**Economic and Social Council**Distr.: General
22 November 2021

Working Party on Noise and Tyres

UN Regulation No. 51 (Noise of M and N categories of vehicles)**Proposal for supplement 8 to 03 series of amendments to UN
Regulation No. 51****Submitted by the Informal Working Group on Measurement
Uncertainties***

Figure 7a Flowchart for vehicles tested according to paragraph 3.1.2.1. of Annex 3 to this Regulation – Correction of pass-by measurements for temperature and if applicable for test track differences

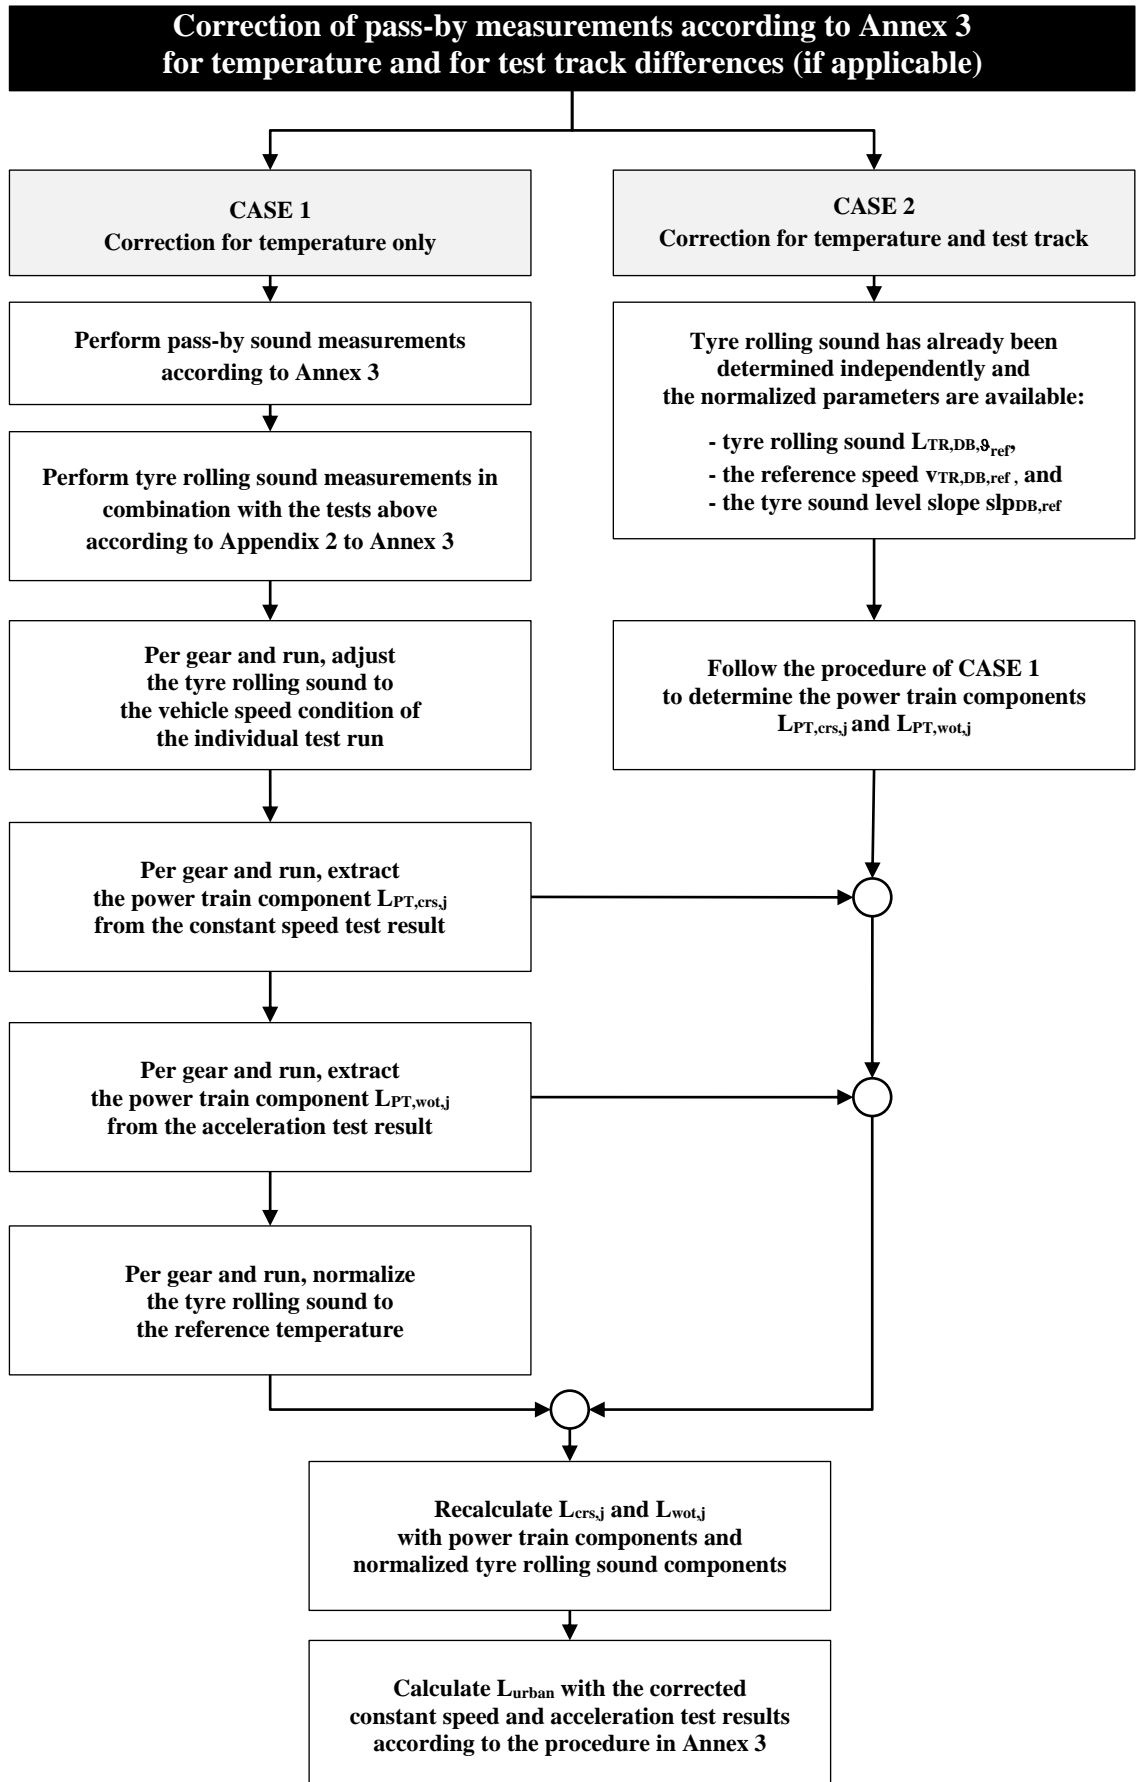
This Appendix contains provisions on the correction for the tyre rolling sound component of pass-by sound measurements of Annex 3 and applies to vehicles of categories M₁ and N₁, and for vehicles of category M₂ having a maximum authorized mass not exceeding 3,500 kg.
2. **General (see the flowchart in Appendix 3, Figure 7a to Figure 7d)**

This Appendix provides correction for temperature and test track dependent on the tyre category and purpose.

Figure 7b Flowchart for vehicles tested according to paragraph 3.1.2.1. of Annex 3 to this Regulation – Temperature Correction for Tyre Rolling Sound Components CASE 1

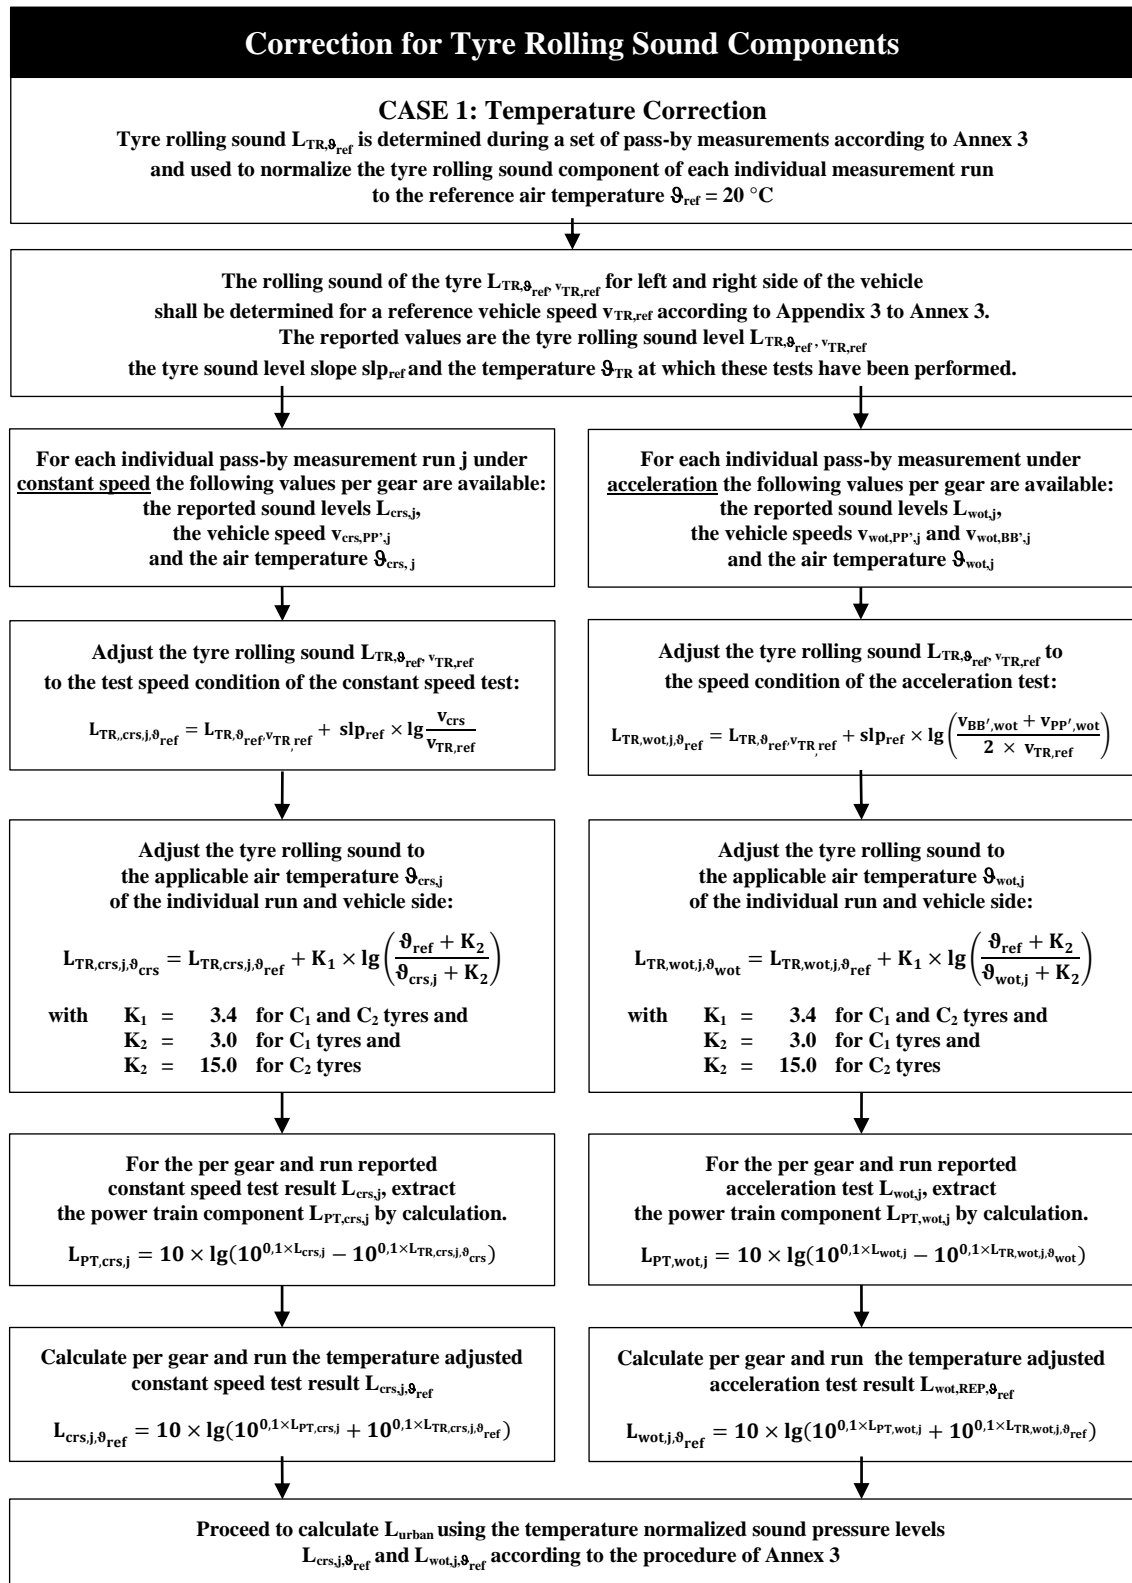
3. **CASE 1**

The temperature correction is based on tyre rolling sound measurements carried in junction with pass-by tests according to Annex 3.

Figure 7c Flowchart for vehicles tested according to paragraph 3.1.2.1. of Annex 3 to this Regulation – Temperature/Test Track Correction for Tyre Rolling Sound Components CASE 2

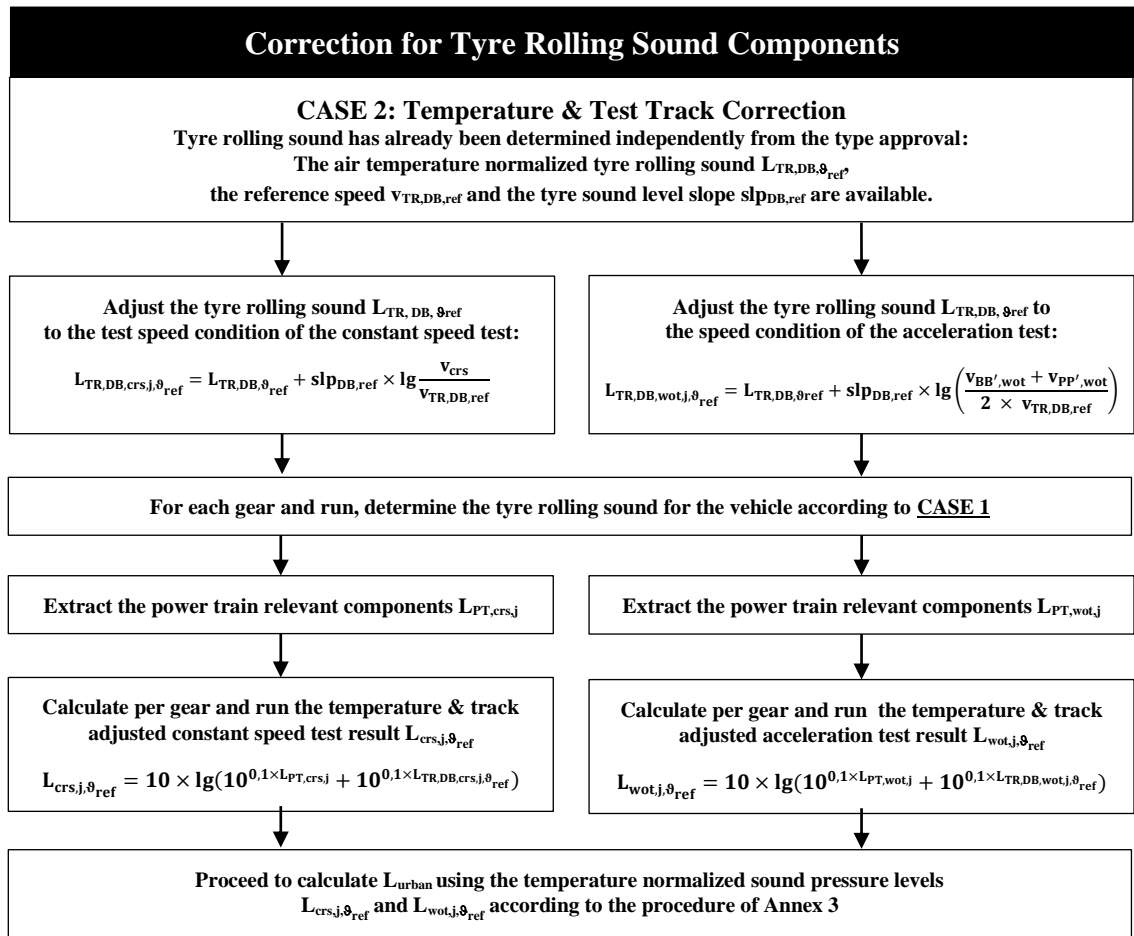
4. CASE 2

The temperature correction based on tyre rolling sound measurements that have been performed independent from the pass-by tests subject to the temperature correction.

Figure A

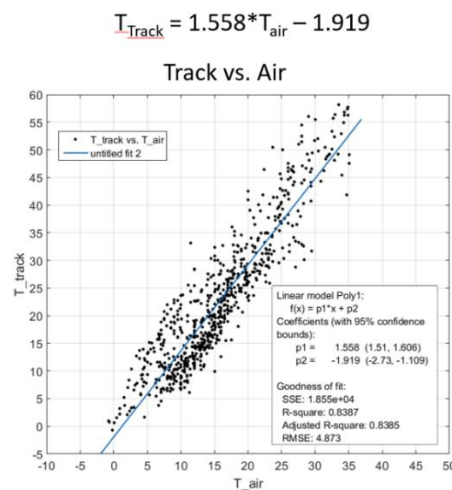
11. Since air temperature is more stable than track temperature due to weather conditions the correction is based on air temperature.

Figure B

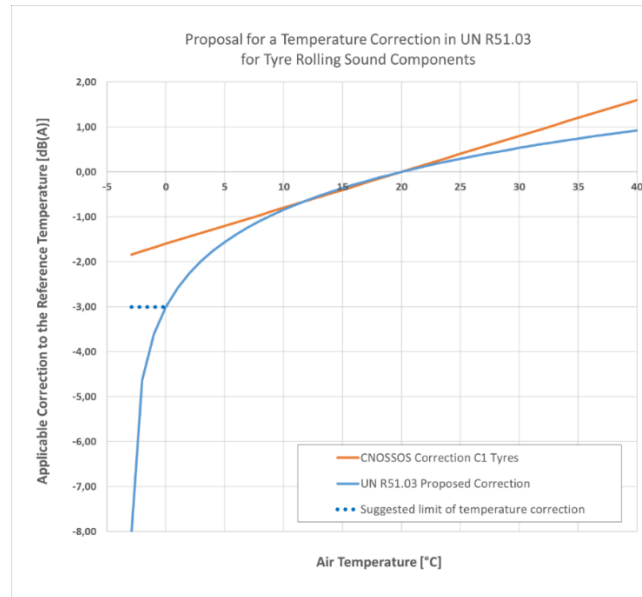
17. The maximum applicable correction is limited to 3 dB(A). This is in line with typical observation on tyre rolling sound for tyres at very cold temperatures.
